Greenfields Battery Energy Storage System

Addendum to the Environmental Statement – clarification update

January 2026

0.1 Clarification update – January 2026

Figure A7.7 Specific Sound Level Map – Daytime and Night-time

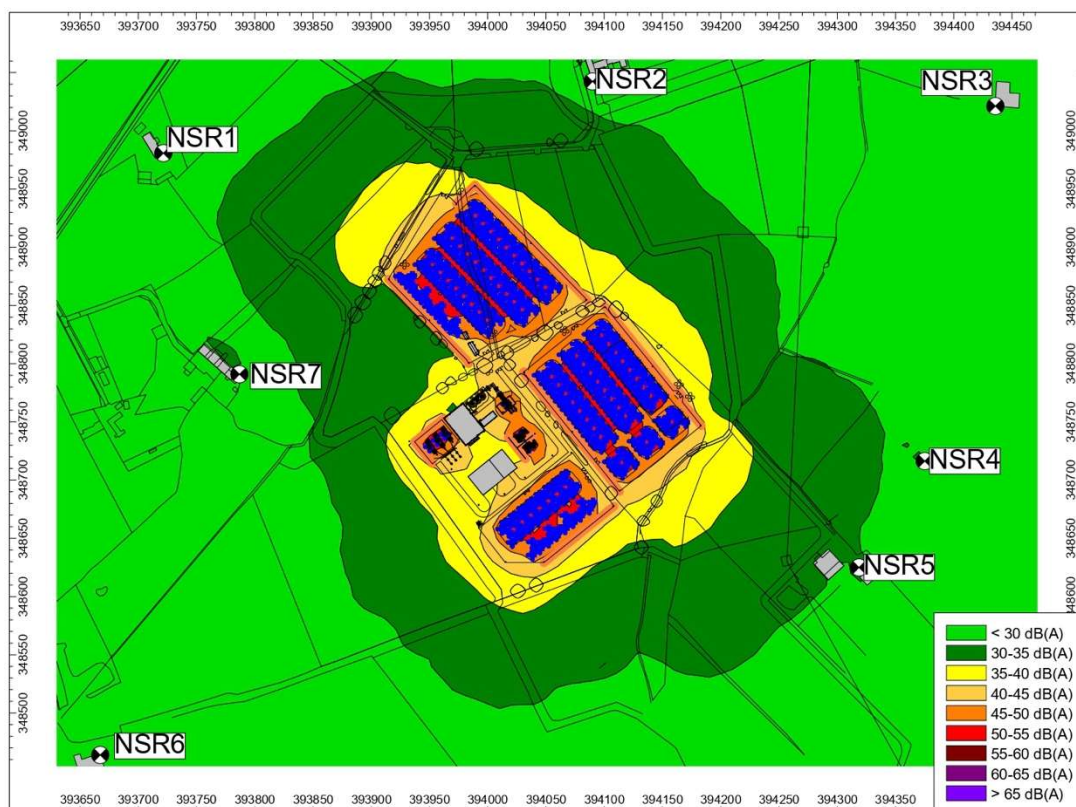
- 0.5.35 Calculations were carried out using Cadna/A software, which undertakes its calculations in accordance with guidance given in ISO9613-1:1993 and ISO9613-2:2024. This is the latest version of the standard, with the original 2024 ES Chapter being completed using ISO9613-2:1996 instead.

- 0.5.36 The sound map showing the daytime and night-time specific sound level emissions from the Proposed Development with acoustic fencing is now shown in Figure A7.7.
